## Town of Arlington, MA Redevelopment Board

### Agenda & Meeting Notice March 29, 2021

### DEPARTMENT OF PLANNING and COMMUNITY DEVELOPMENT

Staff reviewed the following Warrant Articles to provide the Board with information for further consideration as part of the public hearing and review process. There are six articles with public hearings for the evening of March 29<sup>th</sup>. This memo provides information about each article being reviewed, including any additional information provided by the petitioner, and additional factors for the Board's consideration.

#### Illustration A. SideYard Sky Exposure Planes

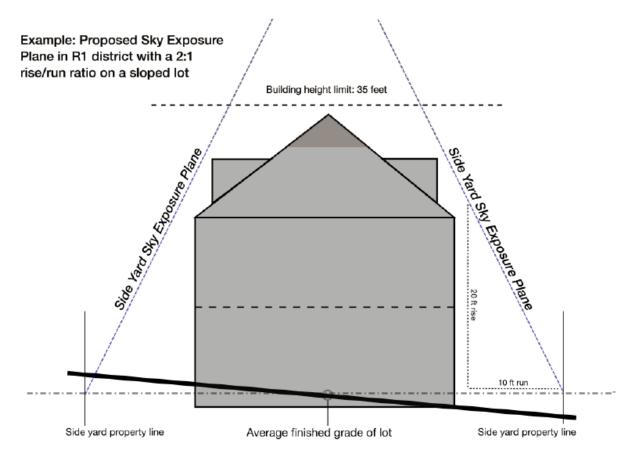
- Solar access The Warrant Article states that one of its purposes is to protect solar access. The practical effect of this Warrant Article might lead to changes in the orientation of the gable end of a roof from front to back to side to side. Depending on the orientation of the street, the Warrant Article might limit the productivity of solar panels if the street is oriented east to west. Additionally, Section 9B of MGL Chapter 40A provides for certain protections for solar access, including allowing the establishment of buffer zones, regulating planting and trimming of tress on public property, allowing an exemption from setbacks building heights, and coverage, and issuing special permits that protect sunlight for solar energy systems. The ARB may want to consider these options for solar access.

- Relationship to the Residential Design Guidelines During 2020, the Design Review Working Group (DRWG) and DPCD staff worked with Harriman to develop residential design guidelines for single- and two-family structures in the R0, R1, and R2 Zoning Districts. The Arlington Residential Design Guidelines<sup>10</sup> were released in December 2020, with support from the ARB, ZBA, and the Design Review Working Group. The Residential Design Guidelines provide area-

The Residential Design Guidelines provide clear guidance for specific areas of town and for specific types of houses, as well guidance for a specific home's relationship to other houses on the block and to the streetscape. For example, and strongly related to this article, the design guidelines recommend "new houses and significant additions should be oriented and located in a way that is consistent with their Neighborhood Block Category" with the accompanying graphic (see page 19):

Overall, the Residential Design Guidelines provide clear and concise information and detailed recommendations that are clear to understand.

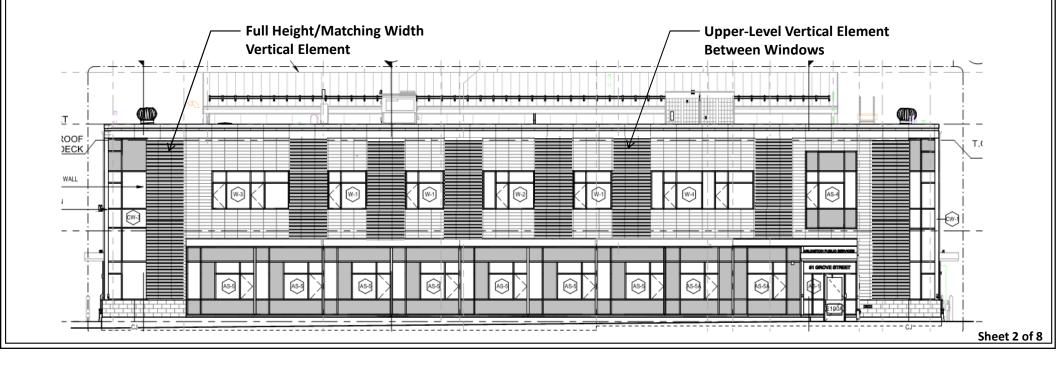
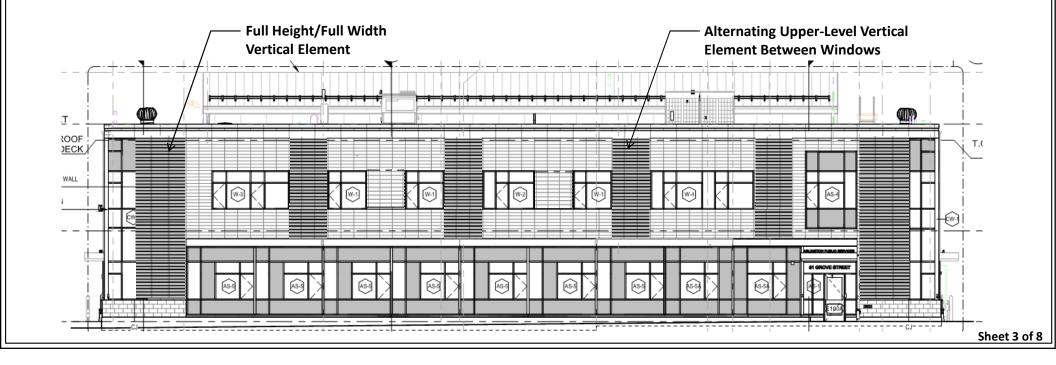
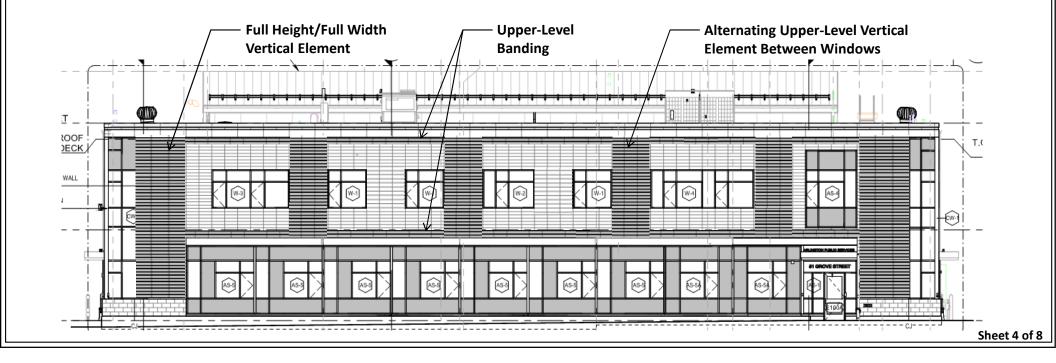
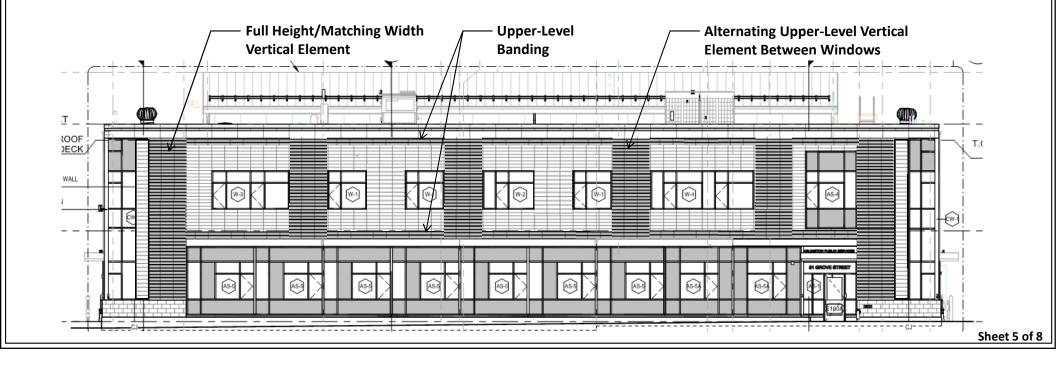
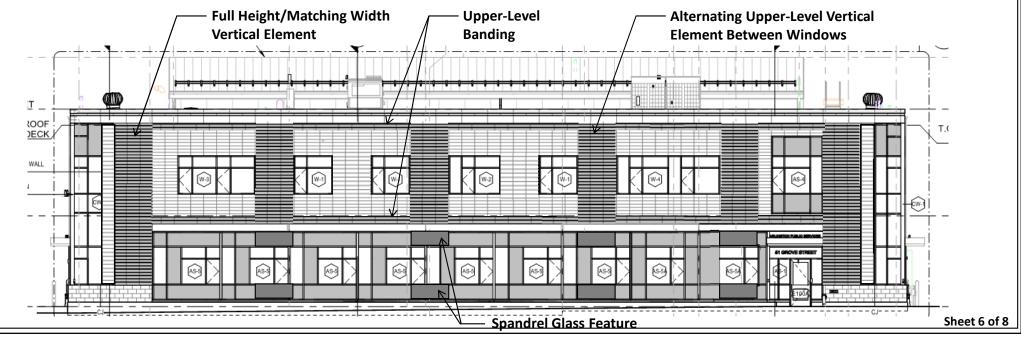
- Response 5: A proposed modification to the exterior siding material color and pattern, at the two-story Administration portion of the building fronting on Grove Street, has been studied and is attached to this letter for the Board's review and consideration. The proposed pattering of the terra cotta panel siding and the layout of the two types of panel profile and color has been modified to introduce a vertical element to mitigate the horizonal / linear quality of the front elevation and to emulate a sequence of building bays, as proposed to address the Board's concerns and review comments. Please refer to the attached building elevation study sketches.

- This plan represents the front elevation of the proposed new Building E as submitted in the January 2021 Environmental Design Review package
- The following sheets (Sheet 2 8) represent a series of elevation studies developed to identify potential modifications to the elevations to address the comments received at the February 22, 2021 Arlington Redevelopment Board meeting

- Introduction of vertical elements at upper-level between windows using alternate material profile and/or color
- Introduction of full height vertical elements using alternate material profile and/or color at entrance towers

- Introduction of alternating vertical elements at upper-level between windows using alternate material profile and/or color
- Introduction of full height / full width vertical elements using alternate material profile and/or color at entrance towers

- Introduction of alternating vertical elements at upper-level between windows using alternate material profile and/or color
- Introduction of full height / full width vertical elements using alternate material profile and/or color at entrance towers
- Banding on upper level using alternate material profile and/or color to further accentuate bay pattern

- Introduction of alternating vertical elements at upper-level between windows using alternate material profile and/or color
- Introduction of full height / matching width vertical elements using alternate material profile and/or color at entrance towers
- Banding on upper level using alternate material profile and/or color to further accentuate bay pattern

- Introduction of alternating vertical elements at upper-level between windows using alternate material profile and/or color
- Introduction of full height / matching width vertical elements using alternate material profile and/or color at entrance towers
- Banding on upper level using alternate material profile and/or color to further accentuate bay pattern
- Use of colored spandrel glass feature on lower-level storefront to extend vertical elements along entire facade
